Model: MET-C1k	Date: 10-Nov-14	No.: RD237002
----------------	-----------------	---------------

Subject: Firmware Release Note: Network Support		Prepared by: E. Hinata	
From: 1st Tech Service Sect., MFP/Printer Tech Service Dept.			
Classification:	<input type="checkbox"/> Troubleshooting	<input type="checkbox"/> Part information	<input type="checkbox"/> Action required
	<input type="checkbox"/> Mechanical	<input type="checkbox"/> Electrical	<input type="checkbox"/> Service manual revision
	<input type="checkbox"/> Paper path	<input type="checkbox"/> Transmit/receive	<input type="checkbox"/> Retrofit information
	<input type="checkbox"/> Product Safety	<input checked="" type="checkbox"/> Other (Firmware)	<input checked="" type="checkbox"/> Tier 2

Model: MET-C1k		Date: 7-May-15	No.: RD237017
Subject: Parts change information (manual feed unit, duplex cover)		Prepared by: E.Hinata	
From: 1 st Tech Service Sect, MFP/P Tech Service Dept			
Classification:	<input type="checkbox"/> Troubleshooting	<input checked="" type="checkbox"/> Part information	<input type="checkbox"/> Action required
	<input type="checkbox"/> Mechanical	<input type="checkbox"/> Electrical	<input type="checkbox"/>

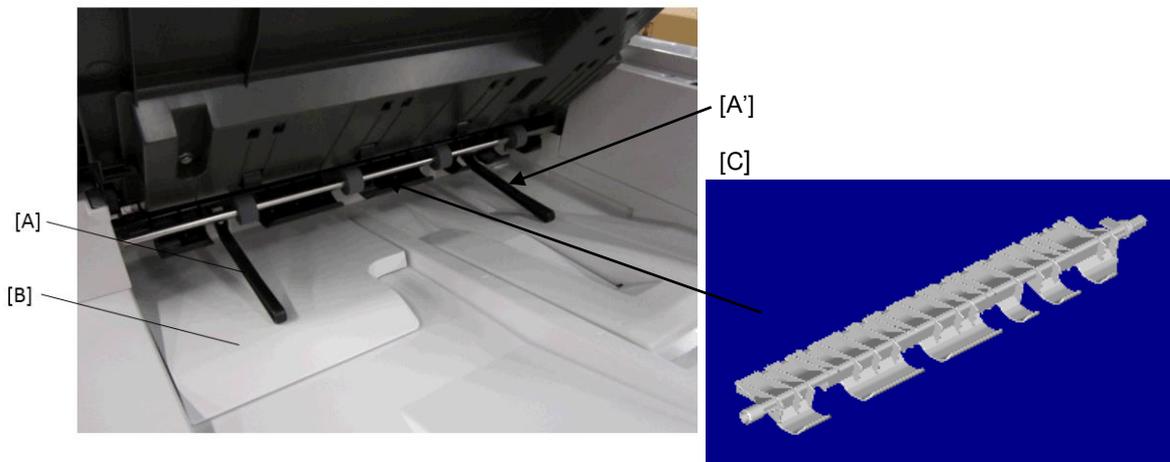
Originals fed from ARDF DF3090 are stacked poorly on the original exit tray.

- Originals are designed to exit slightly faster as soon as scanning completes.
- Original exit tray is not level between the operator and non-operator sides.

1. Added one more paper exit lever.
Note: The photo below shows the existing exit lever [A] and additional exit lever [A].
2. Added an auxiliary tray [B].
3. Modified the gate pawl [C] (to enable addition of a lever).

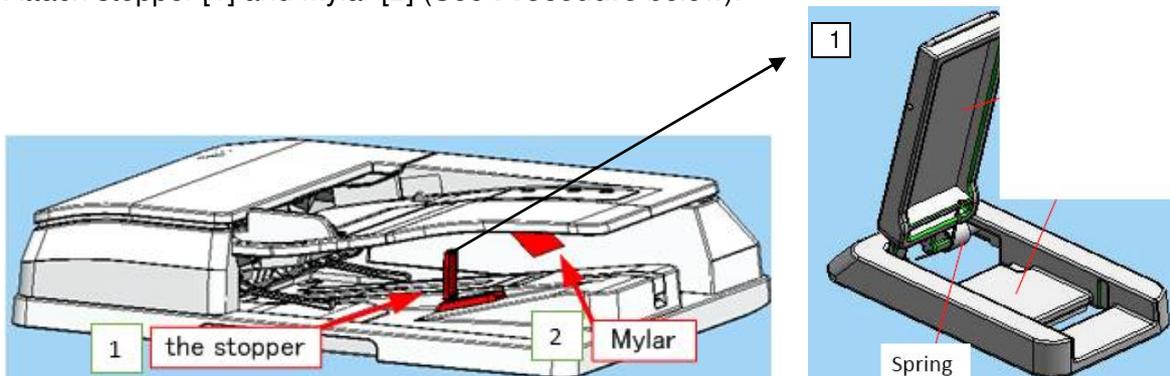
If poor stacking still occurs with A4/LT LEF, attach the following parts.

Attach stopper [1] and Mylar [2] (See **Procedure** below).

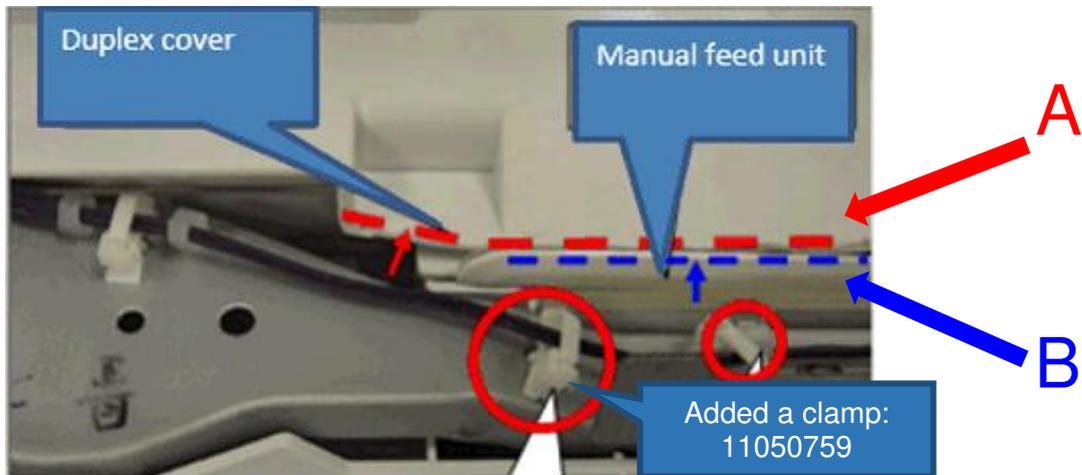
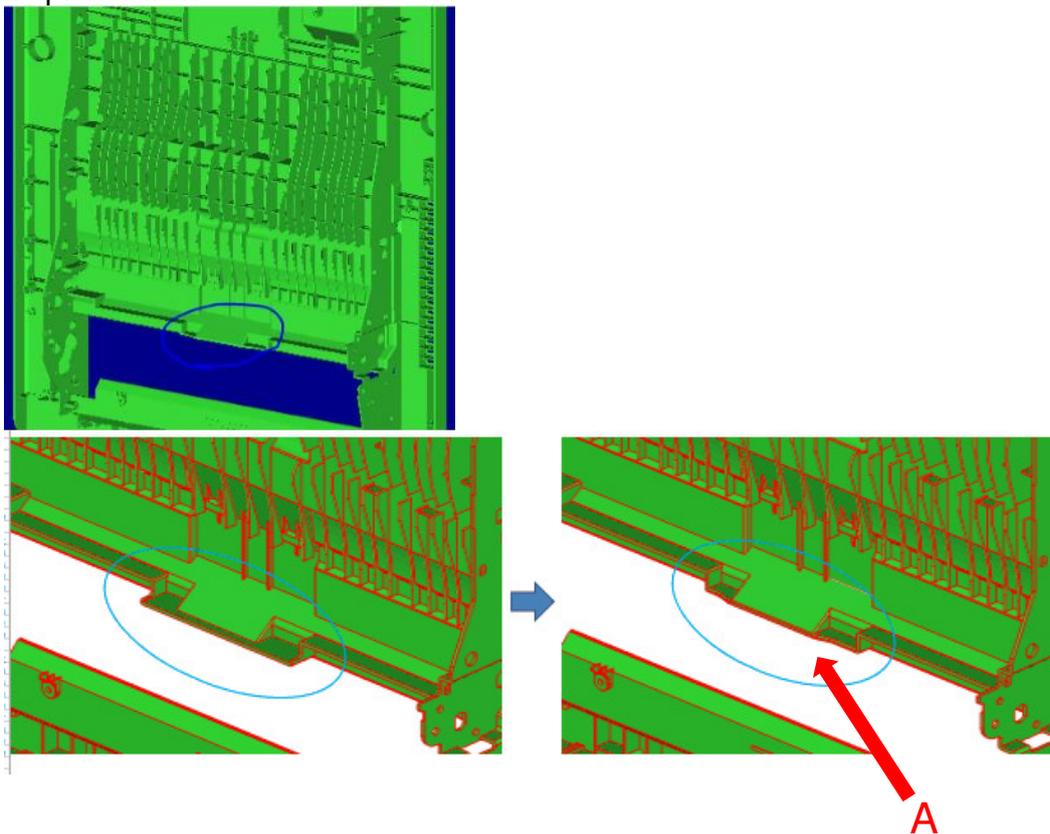
1. The shape of the duplex cover was changed.
2. The shape of the housing in the manual feed unit was changed.
3. A clamp was added to the manual feed unit.

Manual feed unit and duplex cover need to be replaced together.

(Harness is pinched between manual feed unit and duplex cover and then damaged).

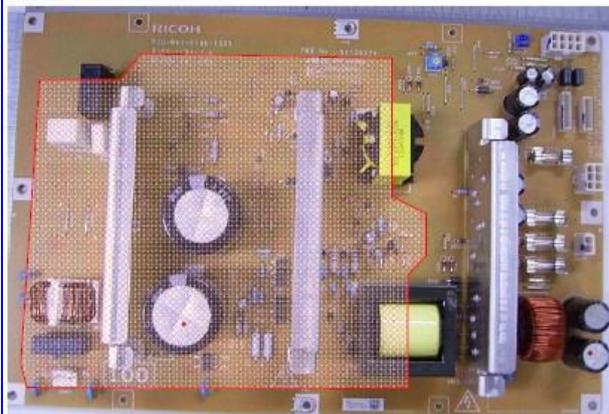
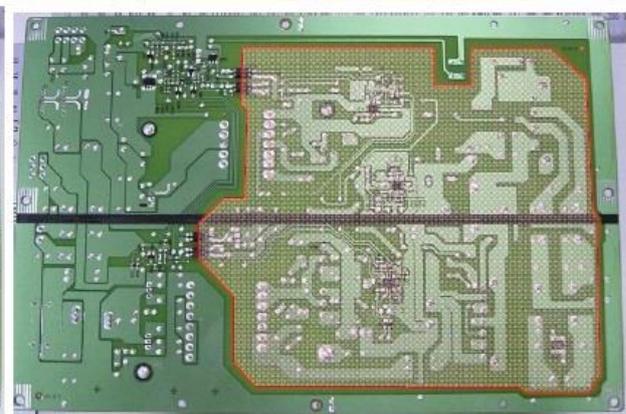
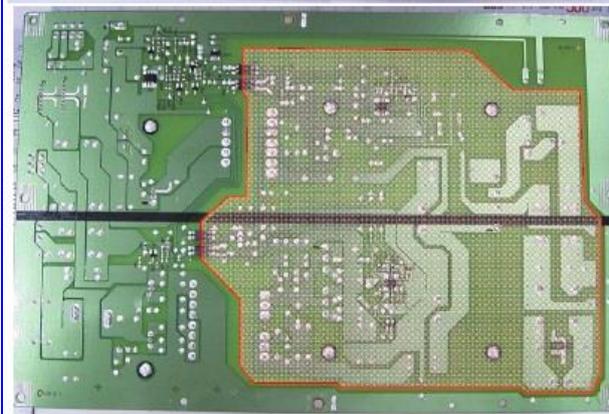
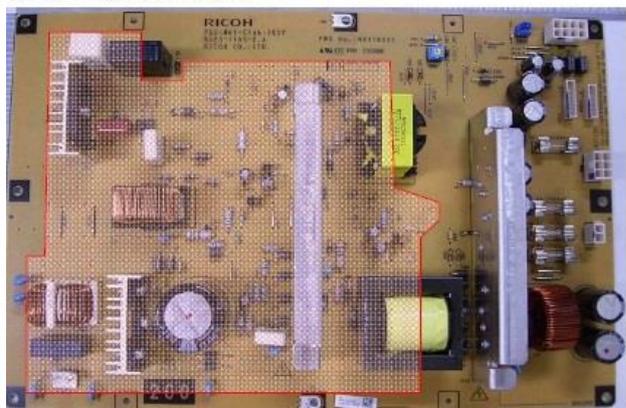
Please add the following caution in the field service manual in this section:
 Replacement and Adjustment > Electrical Components > Printed Circuit/Parts Inside the Power Box

NEVER touch the areas outlined in red in the photos below, to prevent electric shock caused by residual charge.

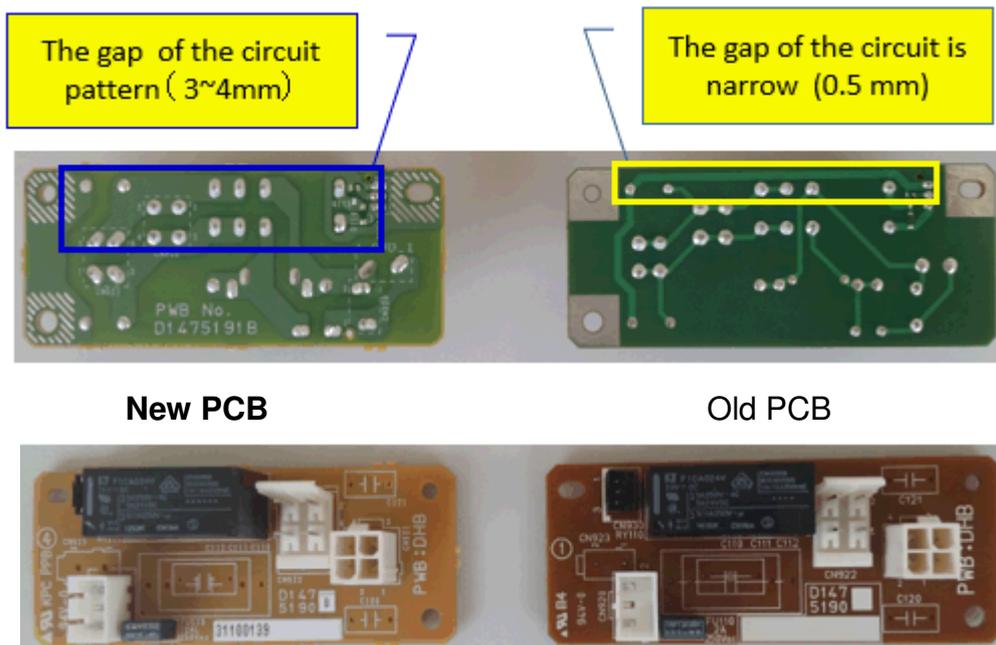
Changed: The design of the PCB: DHB (relay board) was changed.

Reason: To further protect against shorts triggered by high voltage, which can happen if the lines on the PCB are too close to one another.

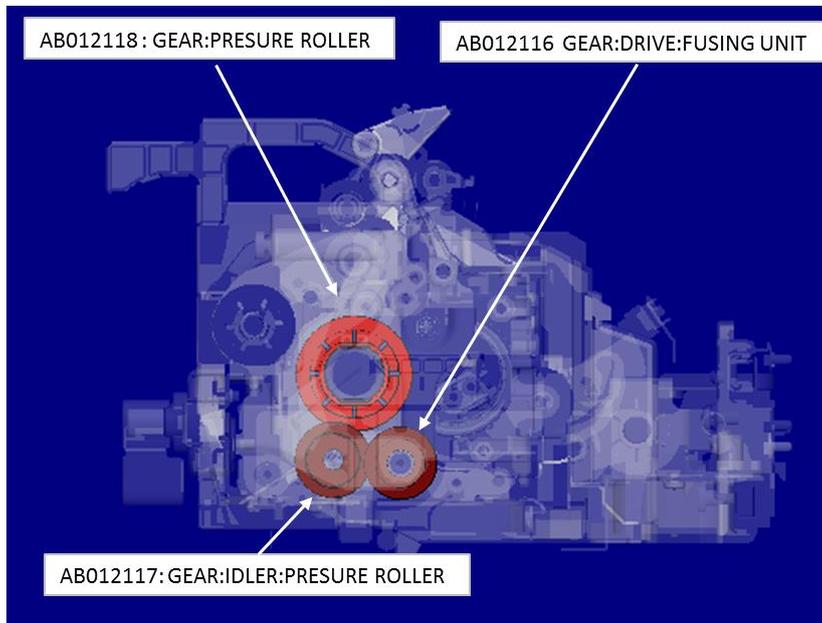
Change: The materials of these parts have been changed ***from April 2016 on Met-C1.***

Reason: To further strengthen the parts' resistance to abrasion.

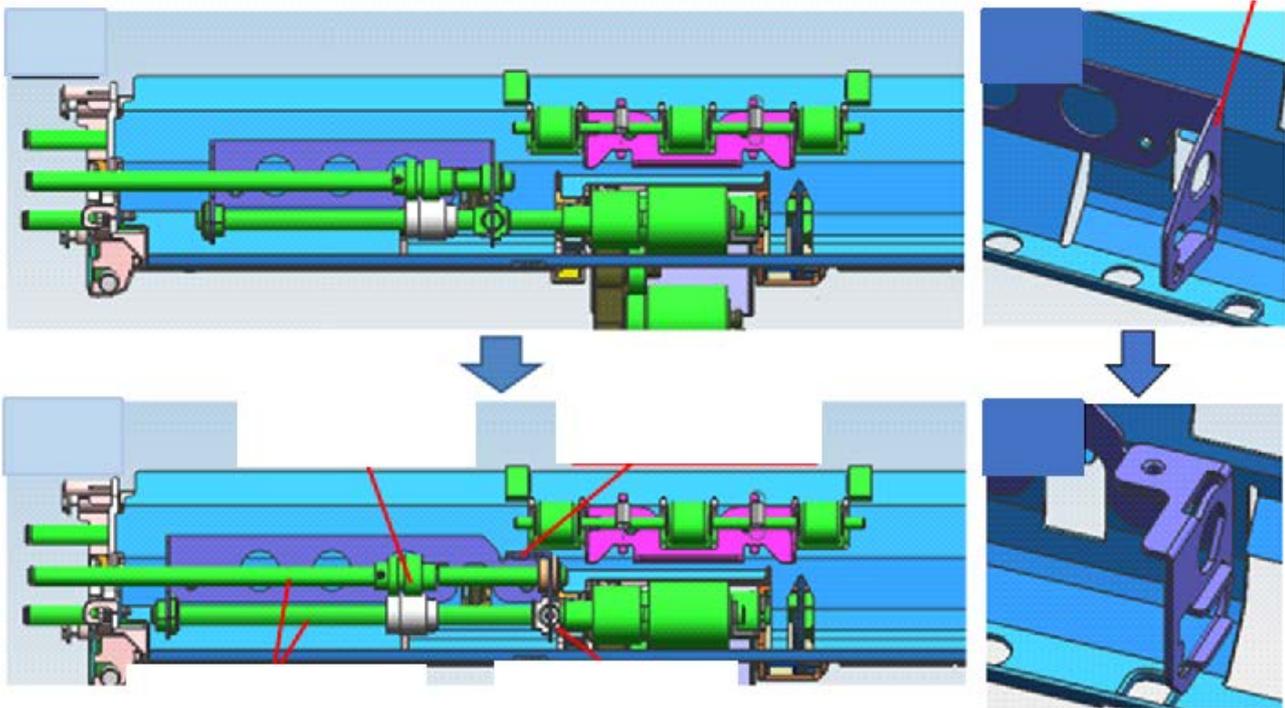
Change 3: The shape of the brackets and bearings, length of the roller shaft, and the gear position has changed. Also e-rings added.

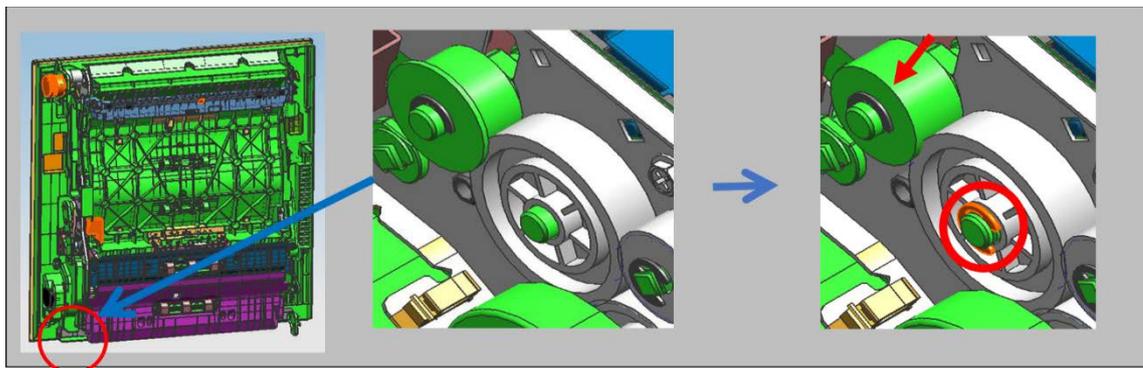
Change 4: There are no protruding parts to hold the gear. An e-ring added to stop the gear in position, and a groove added to the shaft for the e-ring.

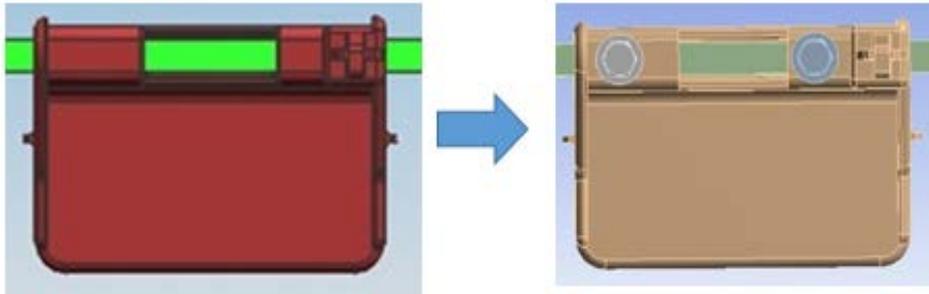
Change 5: The grip of duplex unit has been changed from press fit to screw type.
